Review of V and S Canals Newlands Project

Truckee Carson Irrigation District

U.S. Department of the Interior
Bureau of Reclamation

V-Line Canal

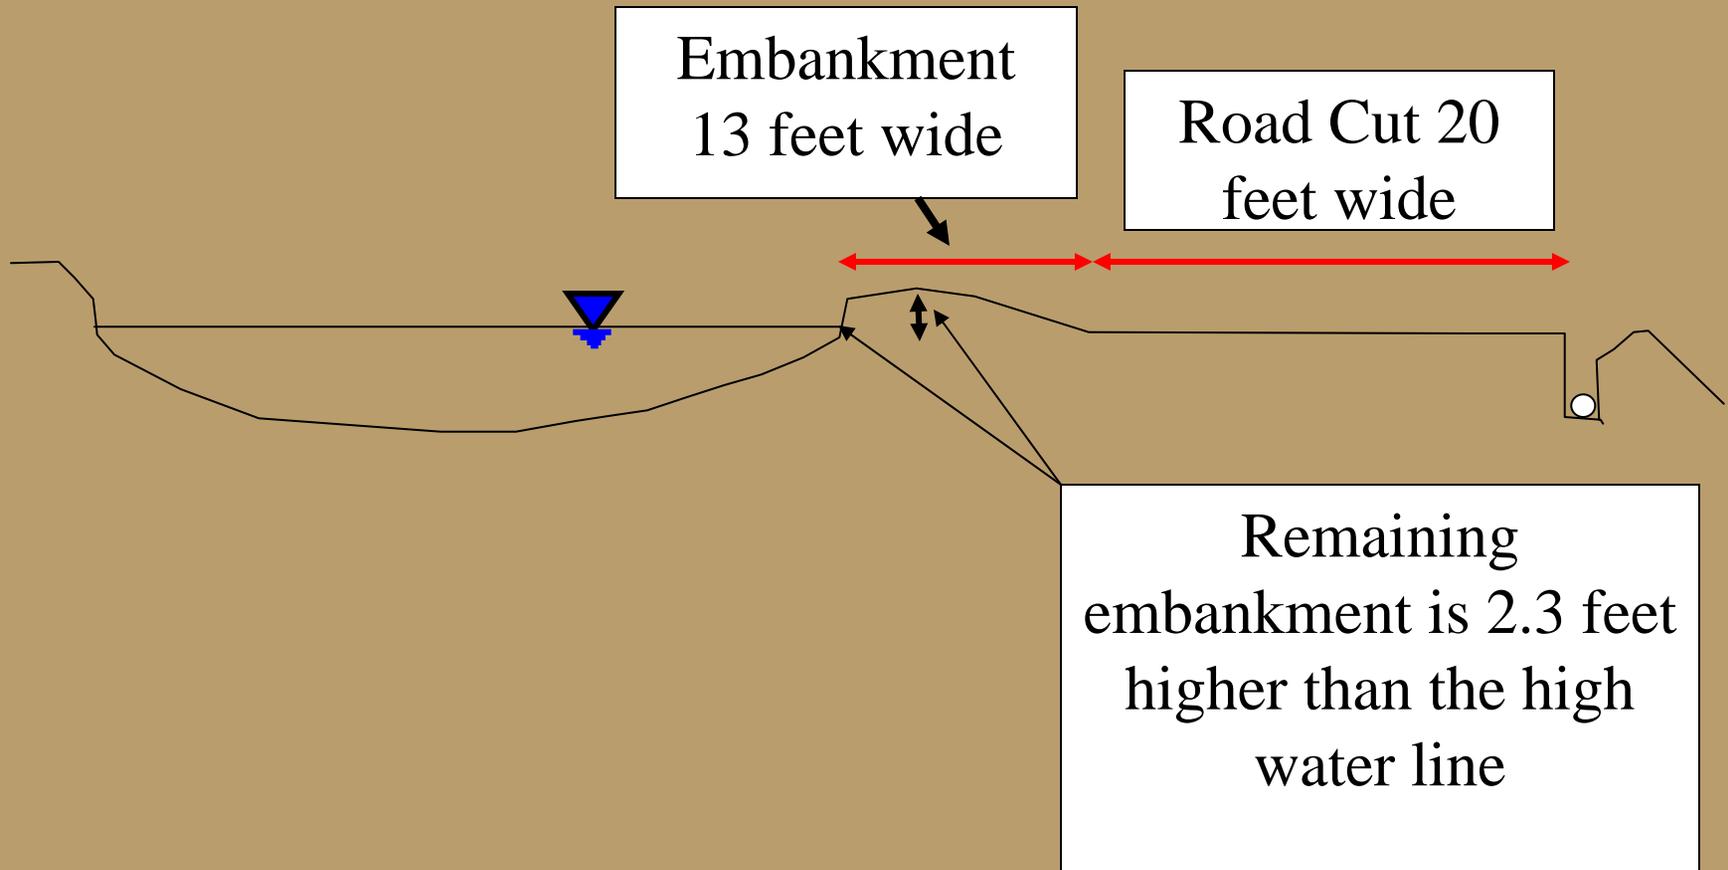
V-Line Canal Safety Issues

Mile Post	Potential Hazard Loss of Life	Potential Hazard Structural Damage	Potential Hazard Loss of Function
5.4 – 5.9	Low	Low to Medium	High

1. From Regan Place to Venturacci Lane, a road has been cut into the right embankment of the V-Line/S-Line canal.

This cut into the embankment puts the road near, or below, the estimated high water line of the canal and narrows the embankment to less than 13 feet wide.

- 1. Determine the high-water operational level allowed in the canal. If the high-water level is above the road elevation restore the original canal width.**

S- Line Canal

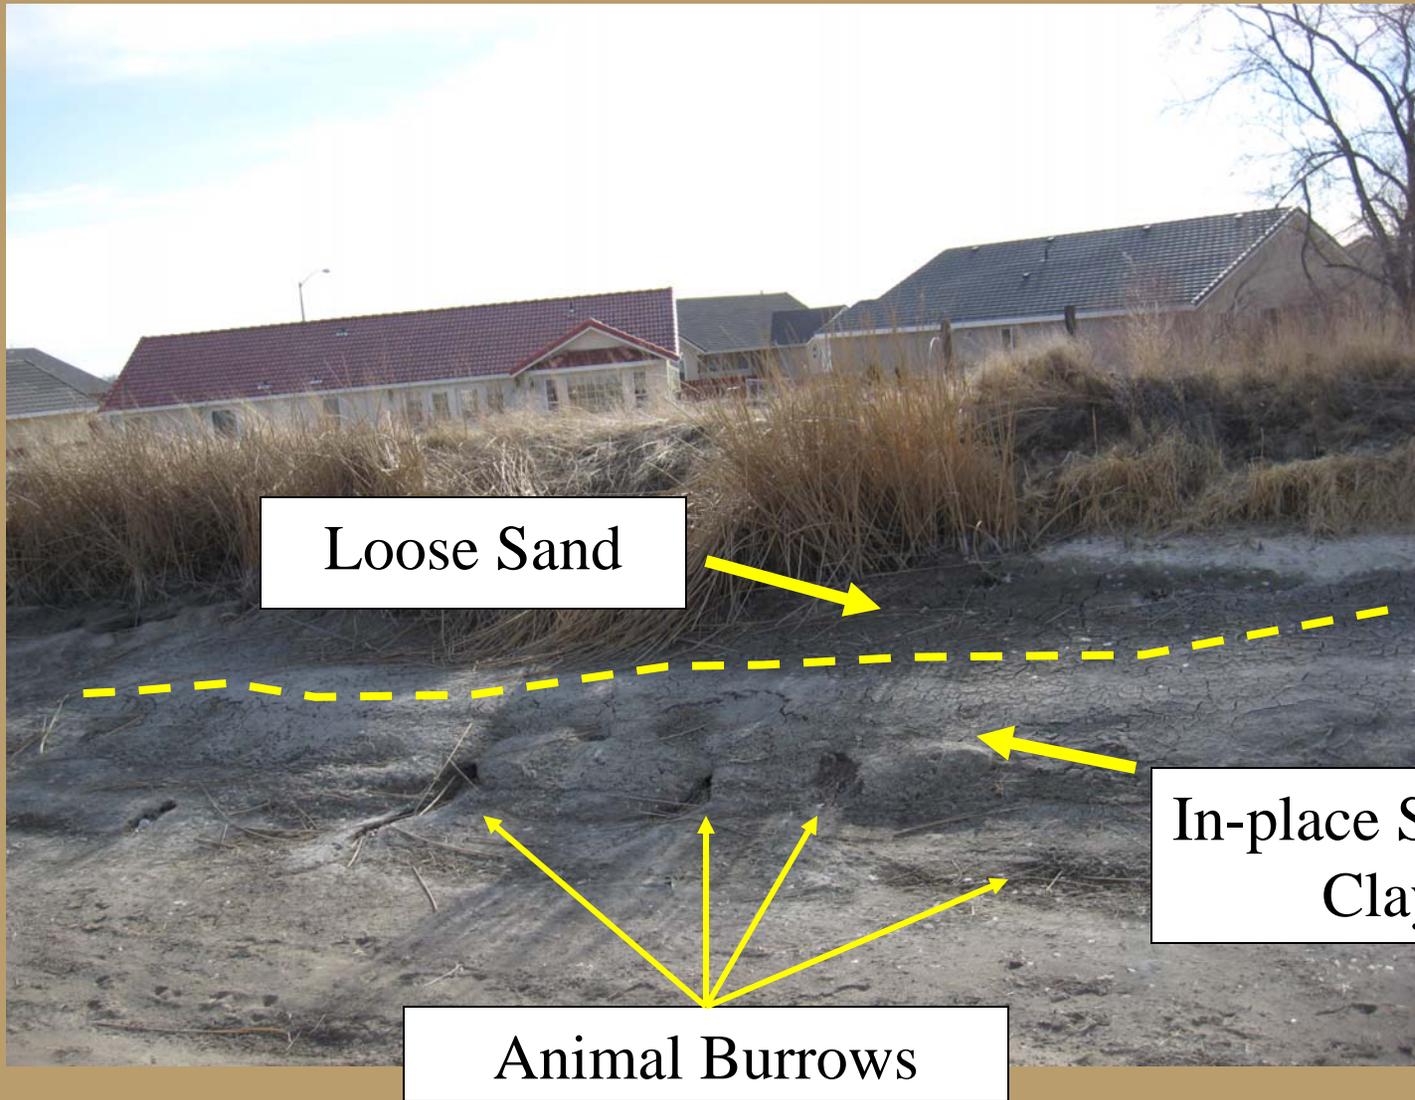
S-Line Canal Safety Issues

Mile Post	Potential Hazard Loss of Life	Potential Hazard Structural Damage	Potential Hazard Loss of Function
1.7 – 1.9	Medium	Medium	Medium

- 1. Extensive creep/sloughing of the right embankment into the canal**
- 2. Abundant vegetation and animal burrows.**
- 3. The upper portions of this embankment appear to be largely composed of sandy non-compacted spoil.**
- 4. Depressions in the embankment suggest the presence of collapsed animal burrows and other potential piping paths**

- 1. Determine the depth of in-place silt relative to high water conditions along the right side embankment.**
- 2. Clear vegetation and fill all animal burrows.**
- 3. Restrict high water level in the canal to below poorly compacted spoil, or reconstruct the upper portion of the right side embankment.**
